REMARKS

By this amendment, Applicants have amended Figure 1 of the drawings as suggested by the Examiner, and have changed the title of the invention to be more description of the invention.

FIG 1
 (PRIOR ART)

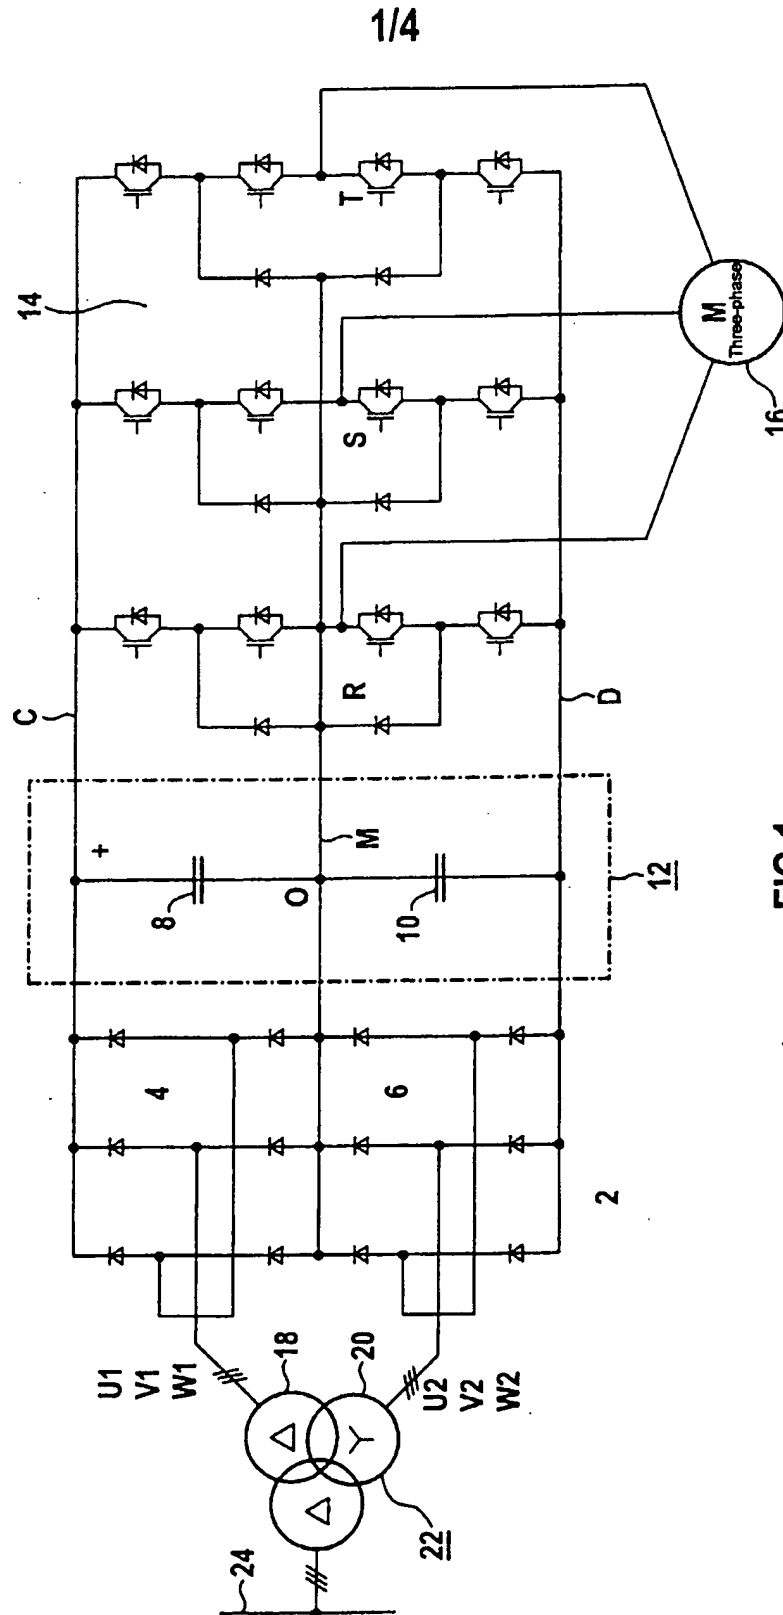
This 12-pulse diode rectifier, as in the case of the rectifier apparatus according to the prior art Fig. 1 of the pending U.S. application is a diode "front end" type. In most cases this
